Rogers MS HVAC Central Kitchen

ADDENDUM #1

ROGERS MS HVAC CENTRAL KITCHEN PROJECT

Date Issued: March 4th, 2026

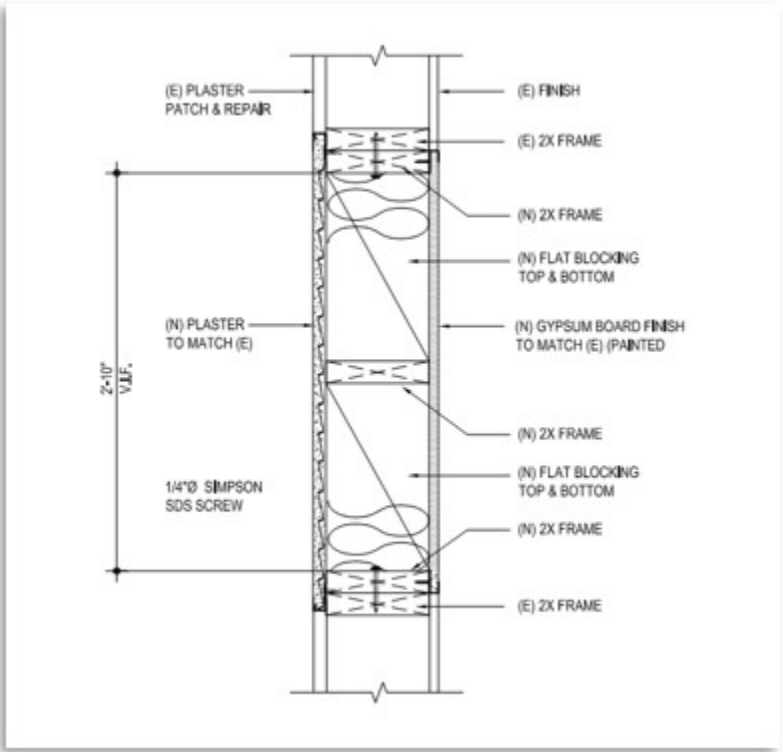
Question 14: M-101 shows us demoing an exhaust and AC unit in the windows can we have a detail how you would like us to cover the opening it will leave when demoed.

Answer: See below.
